DOCUMENT 00913

ADDENDUM NUMBER 3

Issued: April 21, 2015

**Sonoma Valley County Sanitation District
Sewer Trunk Replacement (Agua Caliente Creek Crossing)**

FILE NAME: 7544_XING_CIVIL_Adden
CONTRACT NUMBER: 70-712-7 #7
DRAWING NUMBER: C-1
SHEET 3 OF 14

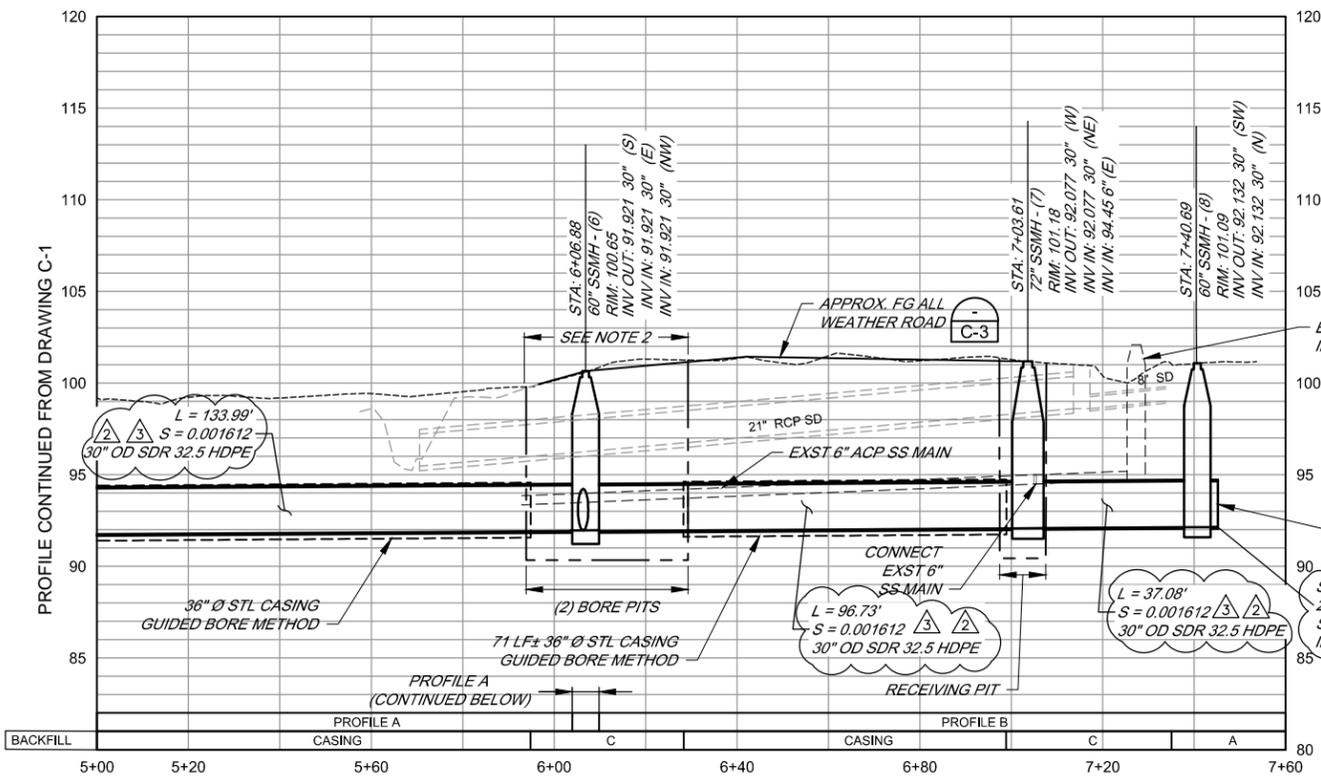
I. Please confirm that Fish & Game will allow us to enter the creek to remove the existing pipe supports as called out for on Sheet C-1 Note 8.

Owner's response: This is in the Bidding Documents. See California Department of Fish and Wildlife 1601, Lake or Streambed Alteration Agreement.

SEWER TRUNK REPLACEMENT (AGUA CALIENTE CREEK CROSSING)	
PLAN AND PROFILE STA 5+00 TO STA 7+40 AND MISCELLANEOUS PROFILES	
FILE NAME: 7544_XING_CIVIL_Adden	DRAWING NUMBER: C-2
CONTRACT NUMBER: 70-712-7 #7	SHEET 4 OF 14

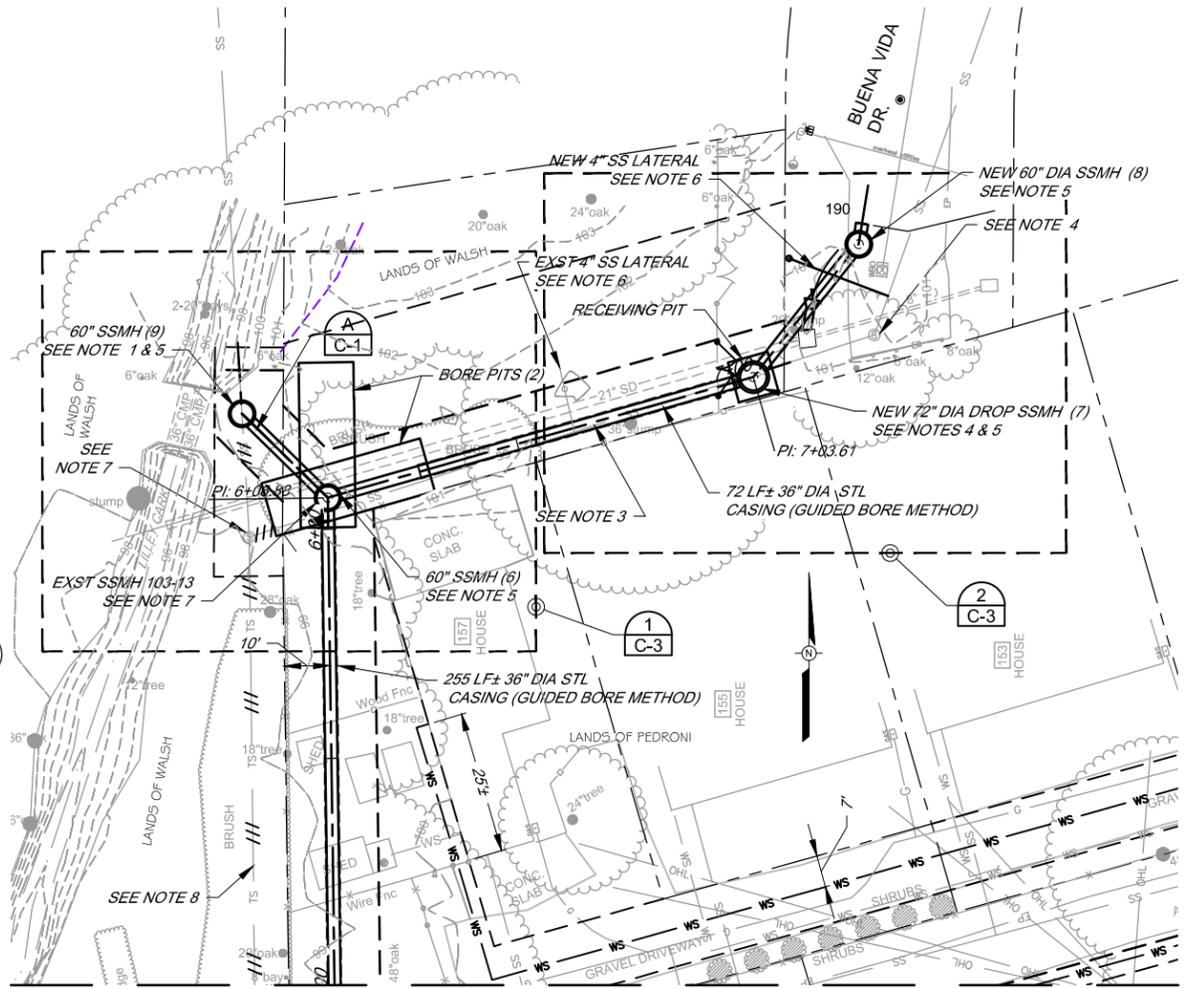
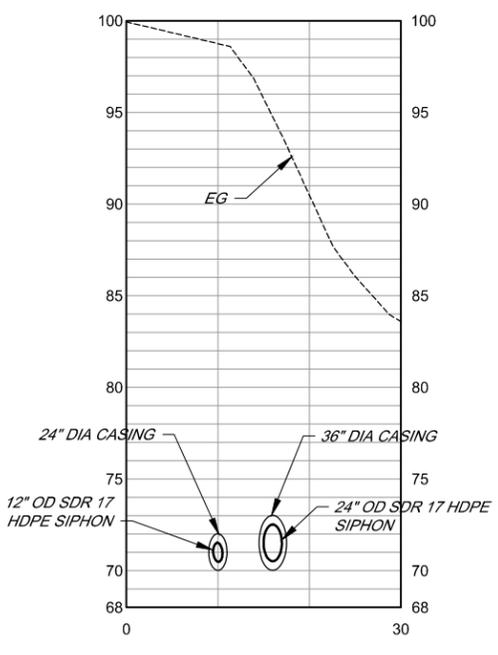
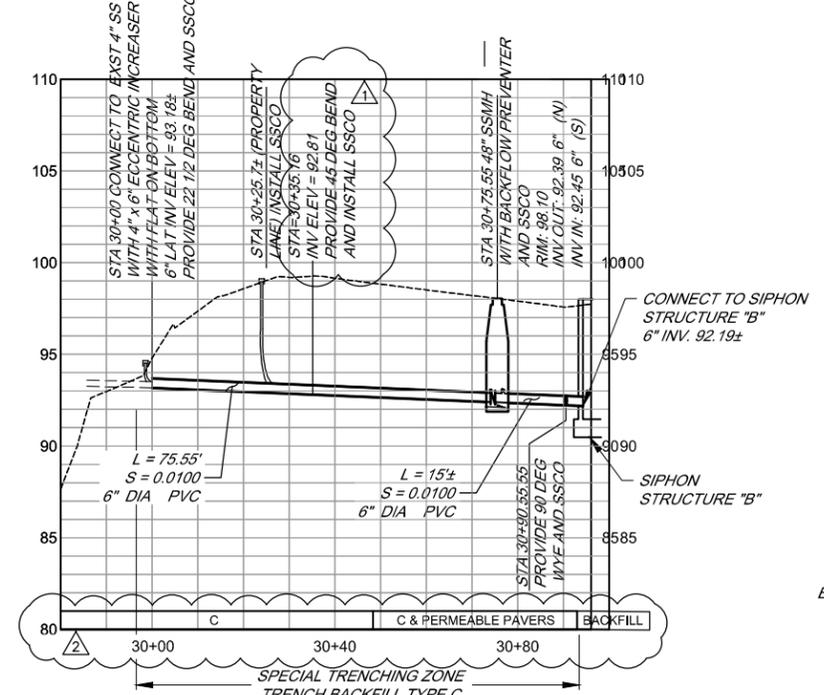
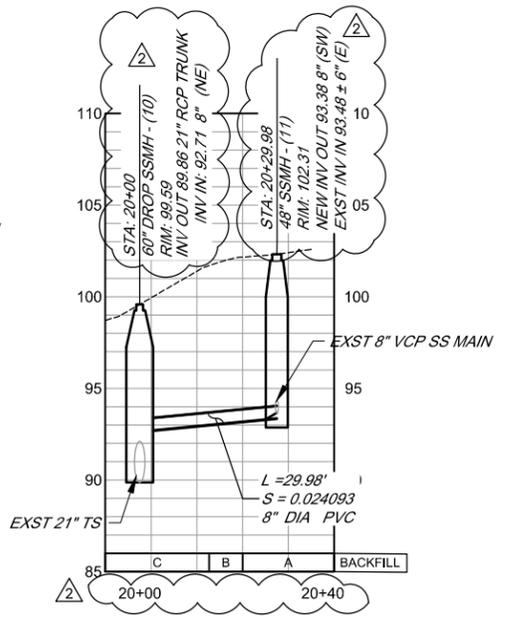
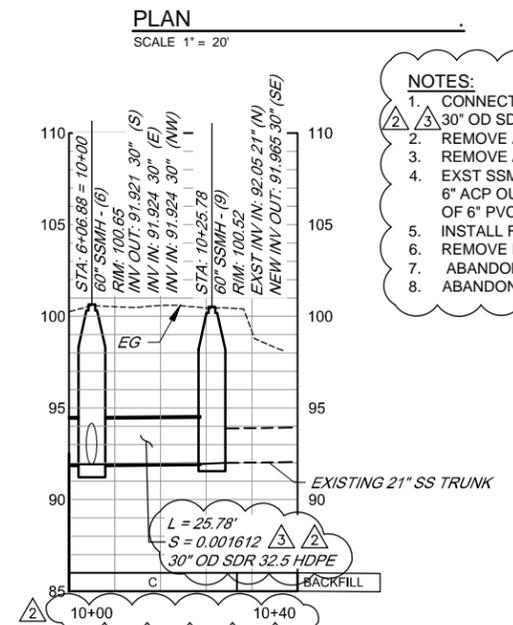
- NOTES:**
- CONNECT EXISTING 21" TRUNK TO NEW 60" SSMH (9) AND PLACE NEW 30" OD SDR 32.5 HDPE SS TRUNK OUTLET TO NEW 60" DIA. SSMH (6).
 - REMOVE AND RESTORE EXST 21" RCP STORM DRAIN WITHIN BORE PIT.
 - REMOVE AND/OR ABANDON APPROXIMATELY 124 LF± OF 6" ACP SS.
 - EXST SSMH 103-14 6" INV OUT 94.71. REMOVE AND REPLACE 9' OF EXST 6" ACP OUTLET PIPE. CONNECT TO NEW TRUNK SSMH (7) WITH 7 LF± OF 6" PVC AT S=0.0100, 6" IN AT TRUNK SSMH (7) = 94.45
 - INSTALL FUSED WALL ANCHOR PER DETAIL 6 DWG C-3.
 - REMOVE EXST 4" ACP SS LATERAL. PROVIDE NEW 4" PVC SS LATERAL.
 - ABANDON EXST SSMH IN PLACE.
 - ABANDON EXST SEWER PIPE.
